From: Jeremy Carter
Sent: Tuesday, June 16, 2026 5:27 PM
To: Martin Bloom; Kerry Lin
Cc: Jeannette Smith
Subject: RE: Street Light Request Form

Request for additional street lighting at 1640 Albany Lane.

Ward 4

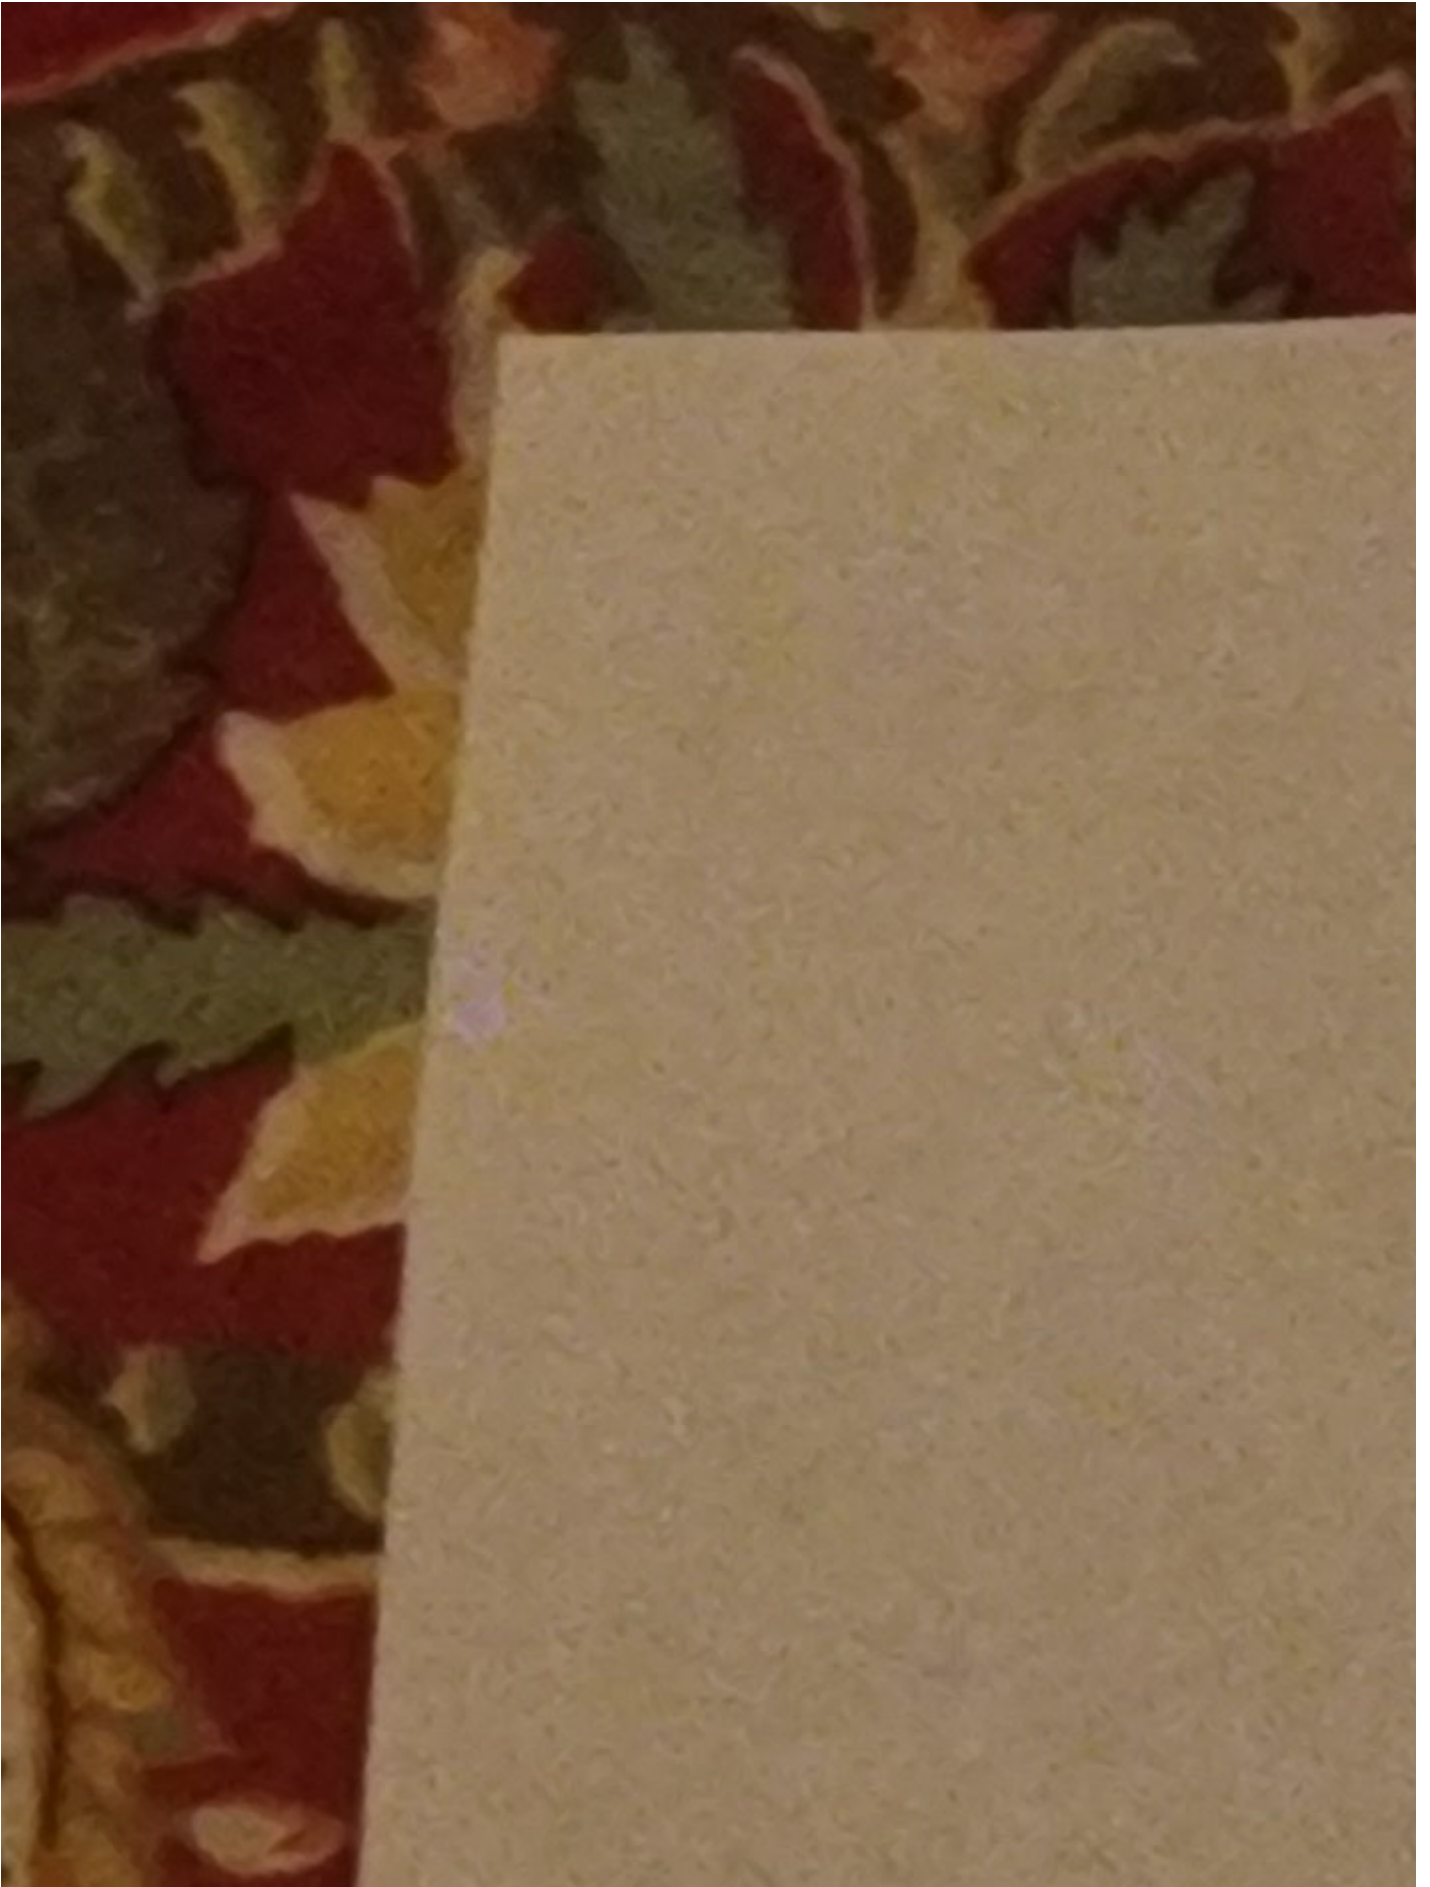
Good morning guys. Jeremy, this is the streetlight request I spoke about this morning. The Police report is attached. As I mentioned there are lights where the arrows are in the picture below.

This would not meet our Streetlight Policy. The light across the street is within 70 feet of you property lines. Streetlights are typically spaced 200-400 feet apart from one another. My next step is to have a crime analysis done on the neighborhood to see if that warrants an additional streetlight. I will be in touch. Thanks.

Good morning. Thank you for your submittal. Could you please let me know where you are asking for the new light to be placed? There are already active streetlights at

1646 Marshfield Dr. and in front of 1633 Albany Ln. So, it may be difficult to get this approved based on the City's Streetlight Policy. But, I will see what I can do based on the location you are looking to have this installed. Thanks
